**RE:** **1017 South Palmway**

**FROM:** Department for Community Sustainability

**TITLE:** **HRPB Project Number 22-00100147:** Consideration of a Certificate of Appropriateness (COA) for the construction of a ±3,660 square foot single-family structure on Lot 1, Block 40 at **1017 South Palmway**; PCN #38-43-44-27-01-040-0130. The subject property is located in the Single Family Residential (SFR) zoning district and the South Palm Park Local Historic District.

**Exhibit A: Proposed New Construction – Street View**

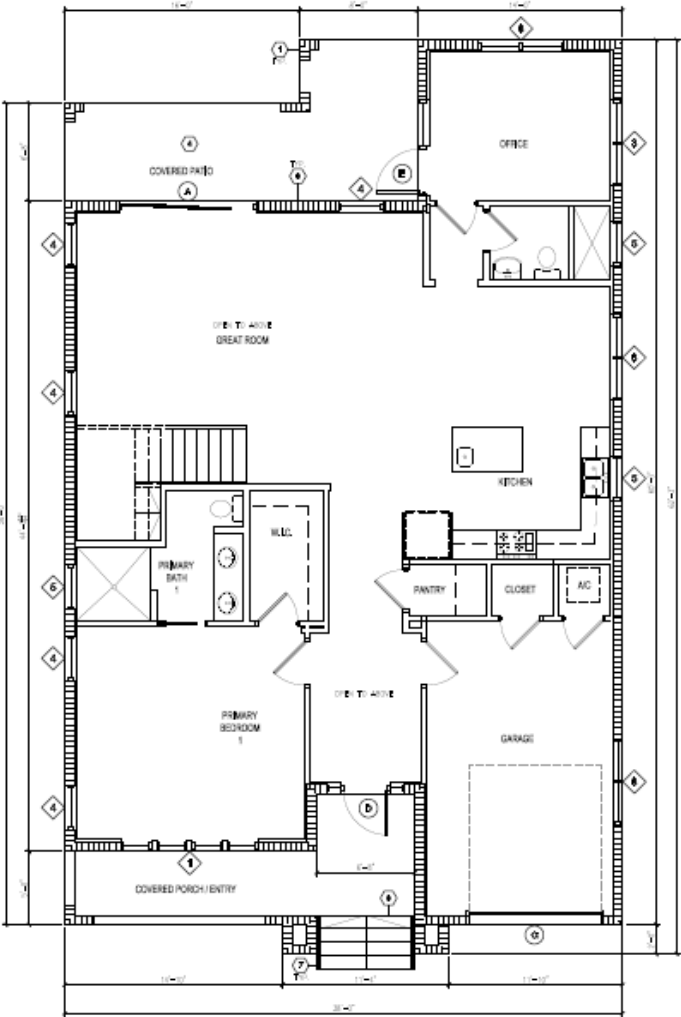
**Staff Analysis:** New construction in a FEMA flood zone is required to meet minimum base flood elevation requirements. For a two-story home, the height of the proposed buildings is visually compatible and in harmony with the heights of surrounding buildings as the low hip roof design minimizes the potential impact of the difference in height attributed to FEMA requirements.

**Staff Analysis:** The width and height of the front elevation of the proposed building are in scale with the surrounding properties on similar parcels.

**Staff Analysis:** The elevations generally avoid long expanses of blank façade.

**Staff Analysis:** The building will be constructed of concrete block and finished with smooth stucco, siding and a low hip roof. These materials are generally appropriate and found throughout the historic districts.

**Staff Analysis:** The proposed roof shape is compatible with the architectural design of the building.

**Staff Analysis:** The site plan includes a stucco and rail enclosure with horizontal rail gates for detailing. The design is generally compatible and complimentary to the surrounding environment.

Exhibit B: Proposed New Construction – Plan View

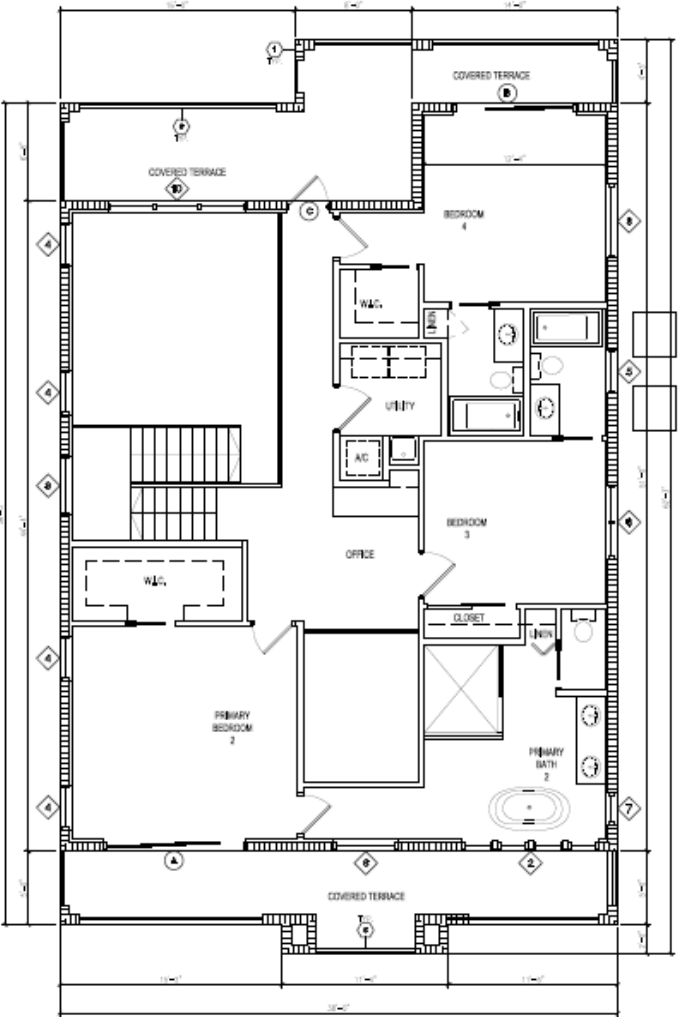
**Staff Analysis:** The proposed siting of the building is generally appropriate and visually compatible with the spatial relationships found between neighboring and similar buildings throughout the district.

**Staff Analysis:** The proposed design utilizes front porches and recessed entryways that are visible from South Palmway. The entryways are connected to the public sidewalk via a concrete paver walkway.

**Staff Analysis:** The proposed new construction project is generally consistent with all site data requirements in the City’s Zoning Code. The proposed site design, including off-street parking, and walkways are generally compatible with the surrounding neighborhood. If approved by the Board, staff has included a condition that final site plan review and approval will occur at building permit for each lot. However, the proposed fencing/walls depicted in the applicant’s rendering would need to be modified at building permit for compliance with the LDRs.
